SUBJECT: Certain 2000 through 2003 Model Year F53 Chassis - Brake Warning Indicator

RE: 02V-327 (Ford®)
03V-060 (Winnebago®)

SUBJECT: Campaign #88 -Ford® F53 I.P. Brake Warning Indicator

INSTRUMENT CLUSTER BRAKE WARNING LAMP CIRCUIT REVISION

FIGURE 1

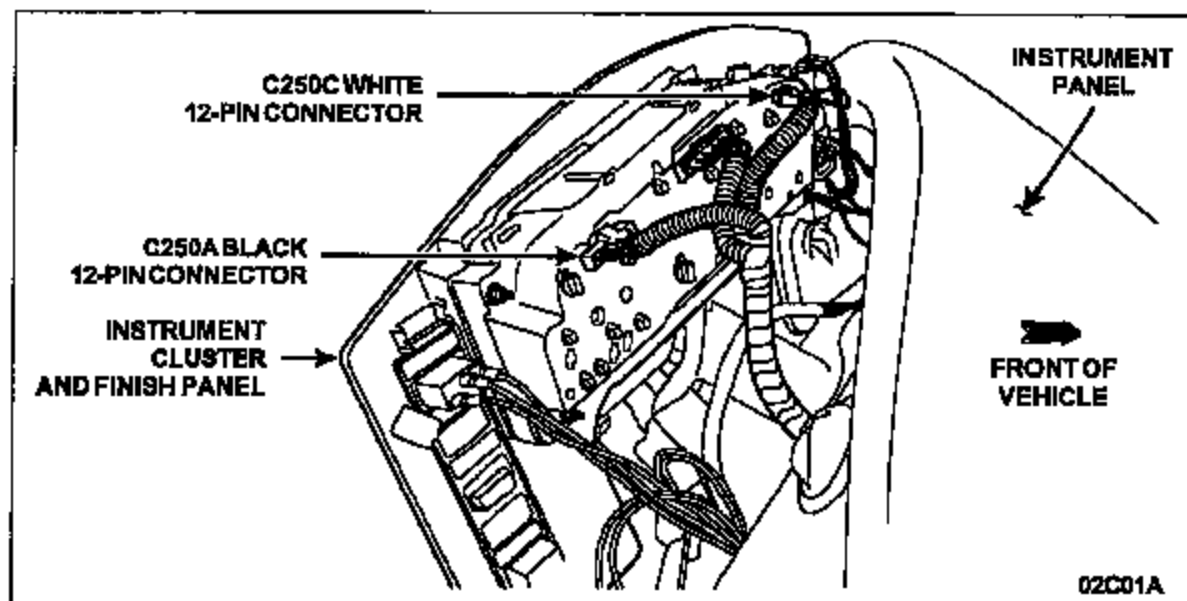
2. Disconnect the C250A (black 12-pin connector) and C250C (white 12-pin connector) instrument cluster electrical connectors. See Figure 1.

FIGURE 2

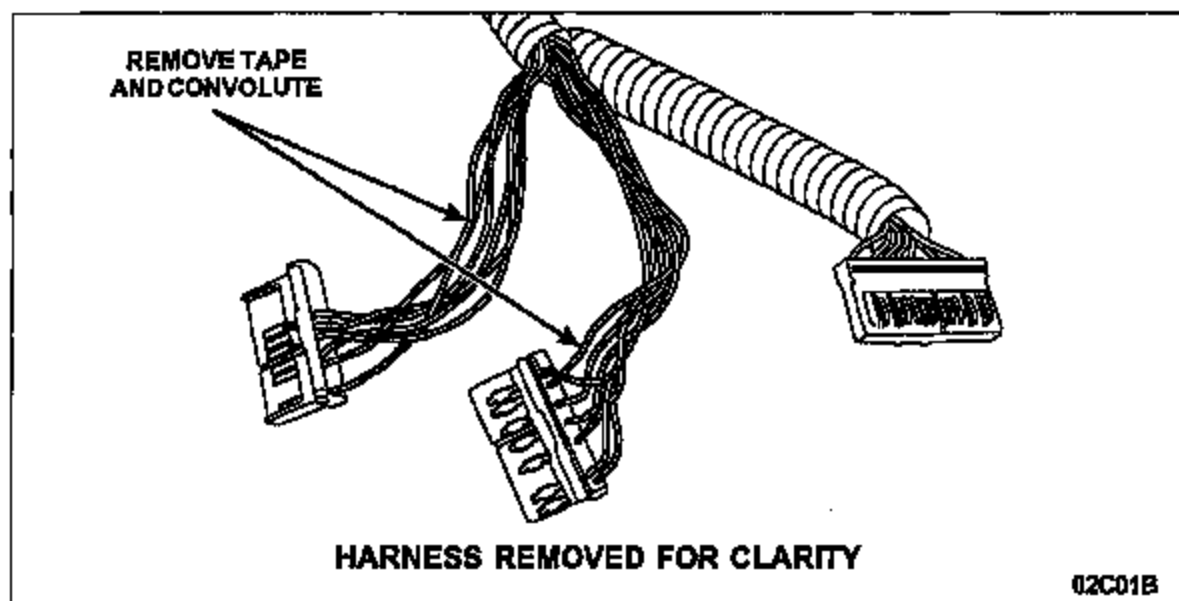
3. Remove the tape and the convolute from the C250A and C250C harnesses up to the point they join the main harness. Retain the convolute. It will be reinstalled. See Figure 2.

FIGURE 3

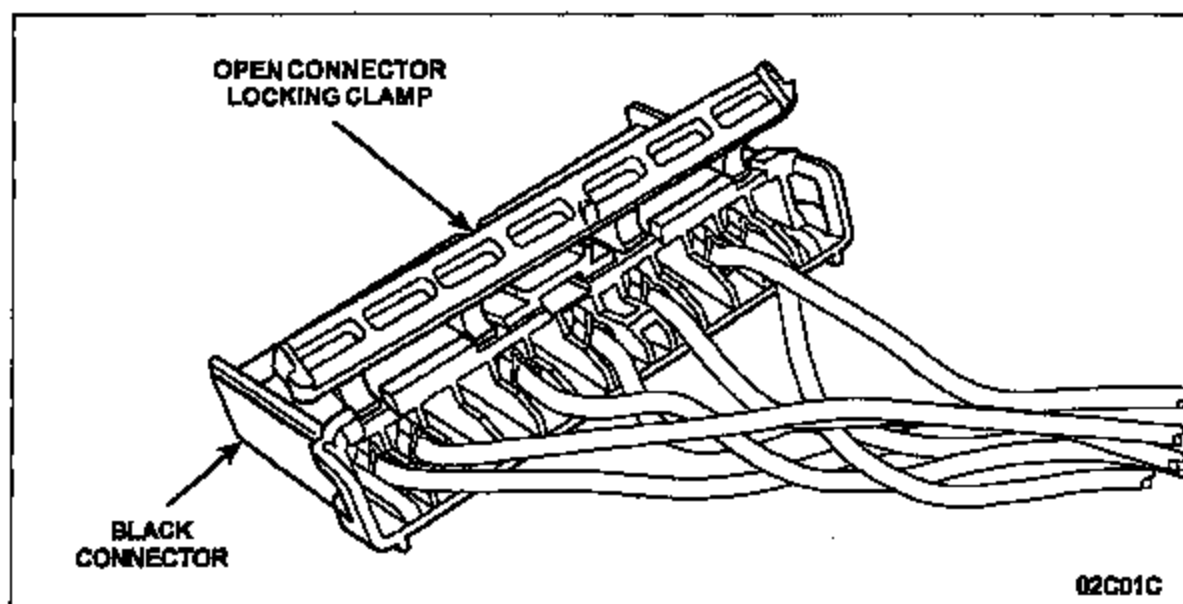
4. Open the black 12-pin connector locking clamp. See Figure 3.

FIGURE 4

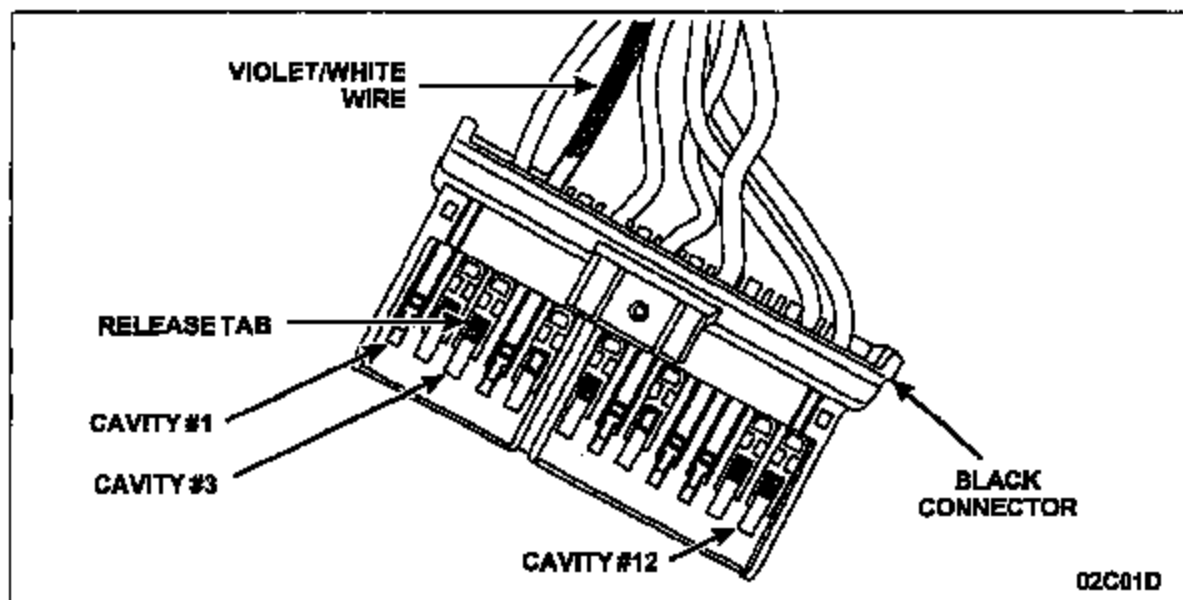
5. Remove the VIOLET/WHITE wire from cavity No. 3 by pushing the small release tab and pulling the wire out of the cavity. Then, close the locking clamp. See Figure 4.

FIGURE 5

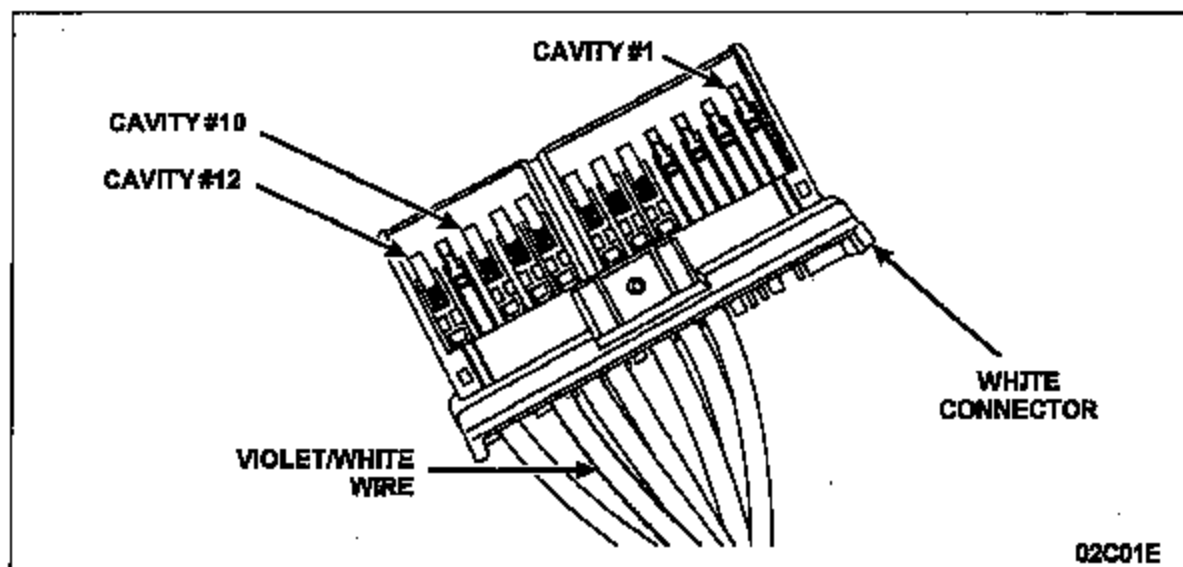
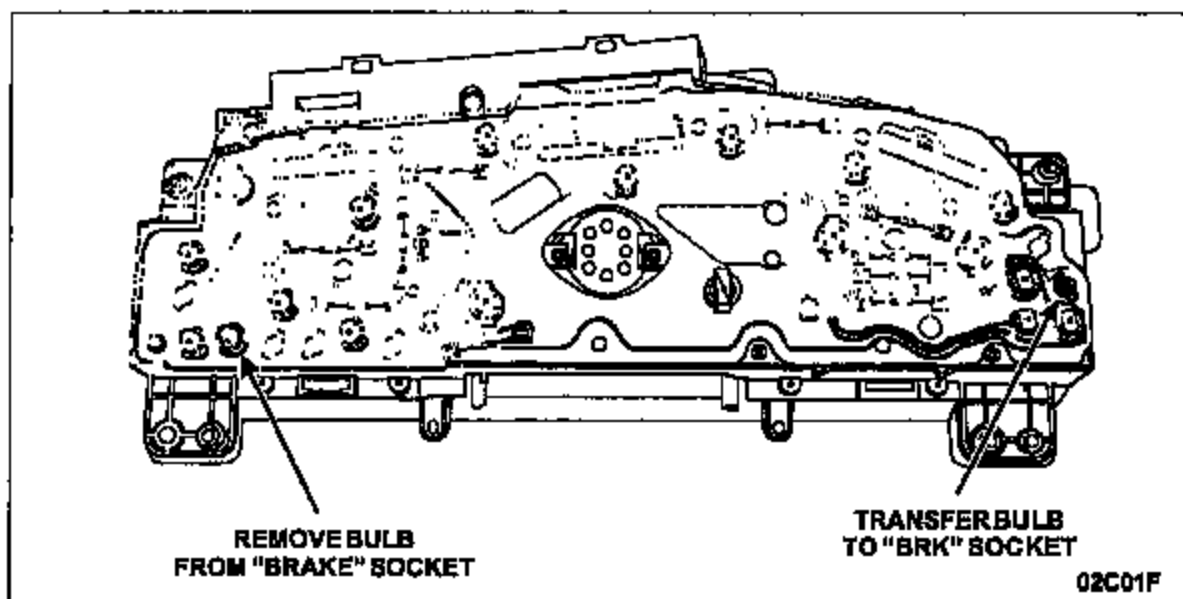
6. Open the white 12-pin connector locking clamp and install the VIOLET/WHITE wire into cavity No. 10. Pull the white wire with light force to make sure it is fully seated. Then, close the locking clamp. See Figure 5.
